**RE: Mayfield West Waste Facility-Mod-1 (SSD-7698-Mod-1)**  
**Request for Additional Information**

In response to your RFI letter (08/06/2021), please find below further information addressing the Department's issues as well as additional issues raised by Council and the EPA.

Figure 1 - Existing water management system

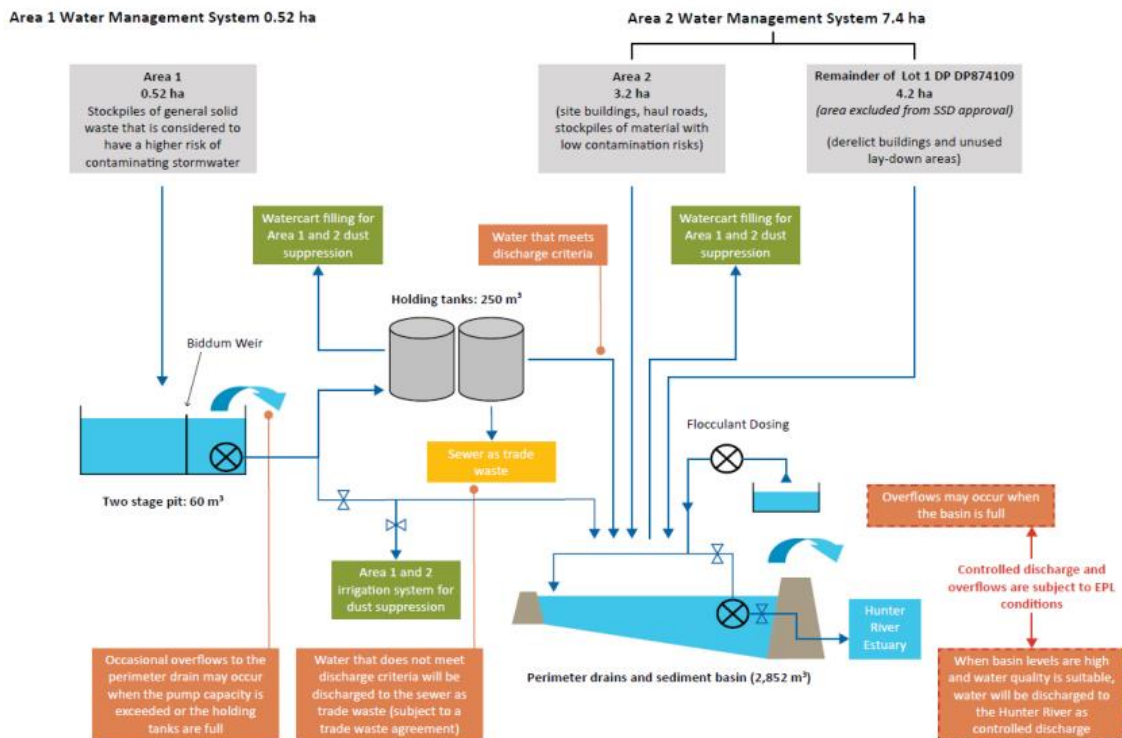
***-The proposed new areas were not included in the updated site water balance provided with the RtS for the original SSD. The updated site Water Balance looked at Area 1 and Area 2 only. Please update the Water Balance to include the new areas proposed for inclusion within the site boundary for SSD 7698.***

**-Figure 8 shows the existing water management system for Area 1 and 2 only. The new proposed Areas would be within the Area 3 catchment in the soil and water management report. Please update the existing soil and water management report to include the new areas proposed for inclusion within the site boundary for SSD 7698.**

**-Please provide an updated assessment of water quality impacts and a site water balance including the new areas.**

The RtS for SSD7698 (EMM 2017) included design storm capacity and water balance calculations (see pages 34 to 37). Both of these calculations applied a 7.9ha catchment area, which includes Area 1 (0.5 ha), Area 2 (3.2 ha) and the remainder of Lot 1 DP874109 (4.2 ha). Hence, it is not possible to 'update' the RtS design storm capacity and water balance calculations as they would be exactly the same. Accordingly, the original assessment (reproduced below or reference the original document) is consistent with the RtS for SSD7698.

The facility's water management system receives surface water runoff from Lot 1 DP874109, which has a total area of approximately 7.9 ha. The materials handling portion of the existing recycling facility is operated in the western portion of the lot, within a 3.7 ha area. The remaining 4.2 ha of the lot is used for ancillary activities approved under Newcastle City Council Development Application DA2015/0291 and includes buildings, storage of empty customer bins and laydown areas. Figure 1 shows the layout of the stormwater system.

The proposed 0.4 ha increase in the area of the recycling facility will not change the stormwater system in any way as:

- Runoff from this area currently drains to the existing stormwater system (i.e. the Area 2 water management system will still have a 7.4 ha contributing catchment area – see Figure 1); and

- All general solid waste that is considered to have a higher risk of contaminating stormwater will continue to be stockpiled in Area 1 (see Figure 1)
